An
Coimisiún
Pleanála

Technical Note R500739_TN

Four aviation-related cargo handling units with ancillary office space.

Wastewater Treatment Proposal

Figure 3-1 Groundwater vulnerability mapping with site investigations area (trial hole and percolation test holes) identified

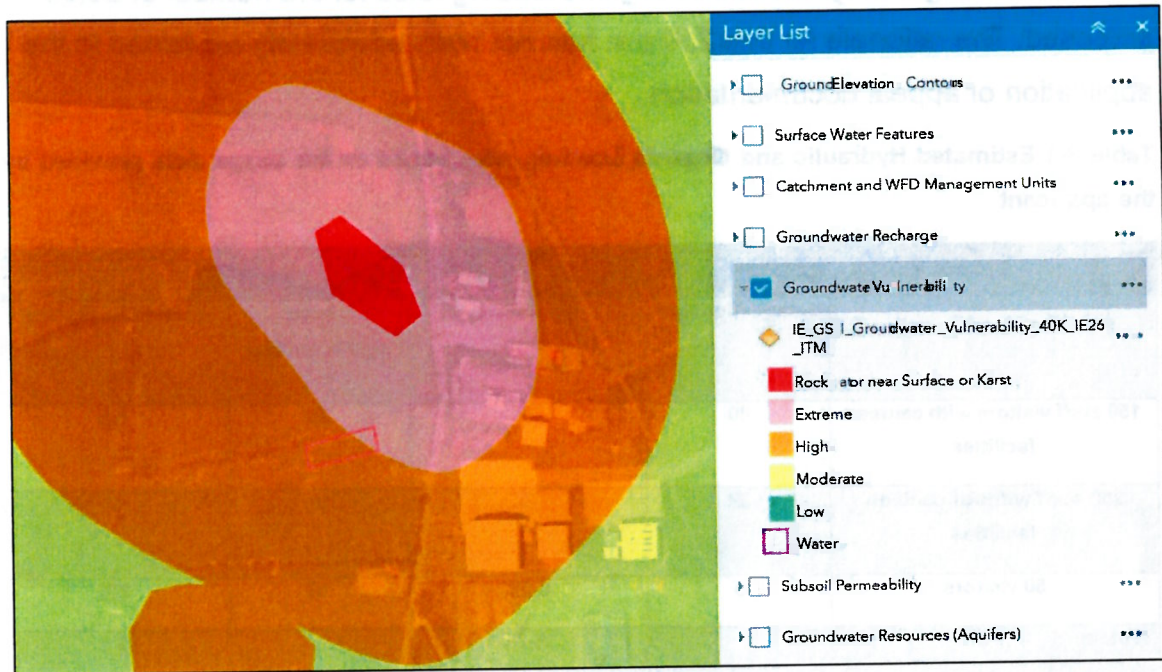
The site characterisation report (SCR) identified the proposed location of the polishing filter to be in an area of High groundwater vulnerability. Having reviewed the online GSI Groundwater Map viewer I believe the proposed polishing filter is located in an area of both High and Extreme groundwater vulnerability (see Figure 3-1 below).

- 3.2.3. With regard to the High/Extreme groundwater vulnerability classification provided by the GSI for this location, along with the photographic evidence provided by the applicant in the SCR, I am not satisfied that the site's suitability has been adequately assessed.
